I am writing to submit my point-by-point responses to the issues raised by the reviewers for my submitted manuscript entitled “*Measurement of the $^{64}\text{Zn}, ^{47}\text{Ti}(n,p)$ Cross Sections using a DD Neutron Generator for Medical Isotope Studies*” for publication in Nuclear Instruments and Methods in Physics Research Section B. Please find my responses detailed in **red text**.

Reviewer #1:

figure 1: Zoomed-out version of Figure 5 from the manuscript.

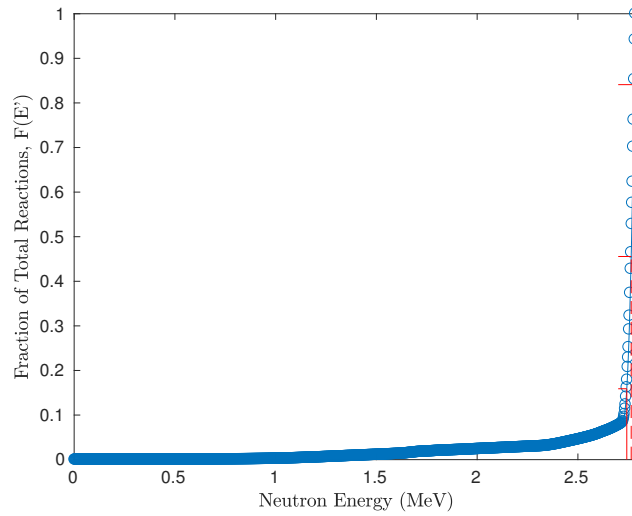
- 2) In an activation measurement the integral of the neutron spectrum and cross section determines the yield, see. eq.(1). The thresholds for (n,p) on Cu or Ti and (n,n') on indium are not the same. Fig. 5 shows the effective energy range for indium only.

Is there systematic effect on the measured (n,p) cross sections due to the low energy tail of the neutron spectrum shown in Fig. 4 ?

The interpretation of the ^{115}In capture cross section effective energy is not clear.

- We thank the referee for touching on an interesting point. We believe that there is no shift in the magnitude of the cross section, since that is defined solely by the indium IRDFF value convolved with our flux. You are absolutely correct - the thresholds for (n,p) on Zn and Ti are not the same as for In. The difference in threshold causes the contribution to the activation due to energies below the main peak in the neutron energy spectrum, particularly the "low energy tail" near 2.25 MeV shown in figure 4, to be slightly different for the (n,p) reactions as compared to the (n,n') reaction. The only way to take into account this additional activation is by convolving the MCNP-modeled flux with the (n,p) cross sections from a model calculation. This results in an additional systematic uncertainty in the width of our effective energy bin, since the modeled (n,p) cross sections are somewhat uncertain in this energy region.

Fortunately, the effect is quite modest. The contribution to the $^{115\text{m}}\text{In}$ activation in this energy region is 2.17%. The TALYS values for the production of ^{64}Cu and ^{47}Ti indicate that 0.24% and 0.85% of the activation can be attributed to the "low energy tail" near 2.25 MeV. If we assume a $\pm 25\%$ uncertainty in the TAYLS cross sections for the two (n,p) reactions (meaning that the activation fraction could vary from 0.18% to 0.30% for the ^{64}Cu and 0.637% to 1.062% for ^{47}Sc), this would lead to a shift in the effective energy bin of 0.06% and 0.21%, respectively. For the case of Sc, this would correspond to a systematic uncertainty of $\pm 5.7 \text{ keV}$, and $\pm 1.6 \text{ keV}$ for ^{64}Cu - these are within the precision of the current $+10 \text{ keV}/-20 \text{ keV}$ effective energy bin, and can be considered negligible.

The low-energy tail in Figure 5 is not well-visible, due to Figure 5 being zoomed-in to illustrate how rapidly the $F(E')$ quantity rises over the 2.7-2.8 MeV range. The zoomed-out version of this is seen below in Figure 1, which illustrates almost negligible contribution to the total activation until above 2.5 MeV neutrons.

figure 2: Linear y-axis version of Figure 4 from the manuscript.

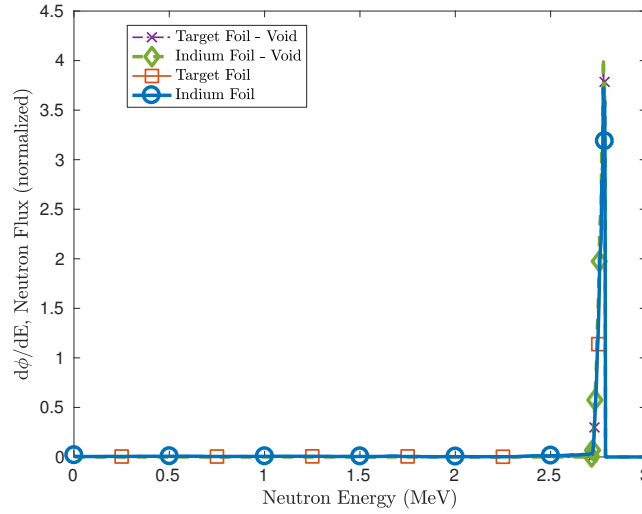
What is the meaning of the data symbols in Fig. 4 and why does the spectrum stop at the highest flux (around 4 units) should it not drop to zero yield above the 2.75 MeV peak ?

- We have made changes to this figure in order to make it more readable - thank you for the feedback to help improve it. Since the indium/activation foil spectra are so very similar to each other in Fig. 4 (and the voided/non-voided neutron production target spectra as well, above approx 2.6 MeV), the markers were added to differentiate the spectra if the manuscript were being viewed in greyscale / by a colorblind individual. Without distinct markers, the various spectra are nearly indistinguishable, due to the proximity of both target and indium foils to the DD reaction surface.

The peak flux occurs at 2.777 MeV - the 2.75 MeV number quoted on P. 3 was a typo and has been corrected. The flux does begin turning down above the peak, and the highest-energy neutron observed is at 2.783 MeV, as noted on P. 3 of the manuscript. Above 2.783 MeV, no neutrons are observed, but a value of $y=0$ cannot be plotted due to the log-y axes. The drop to zero yield may be seen in a linear y-axis version of Fig. 4, seen in Figure 2 below.

These nuances and detailed information about the spectral shape (in particular the rapid rise above the 2.25 MeV shoulder) of the log-y version are masked in this lin-y version, which is why the former was chosen to be included in the manuscript.
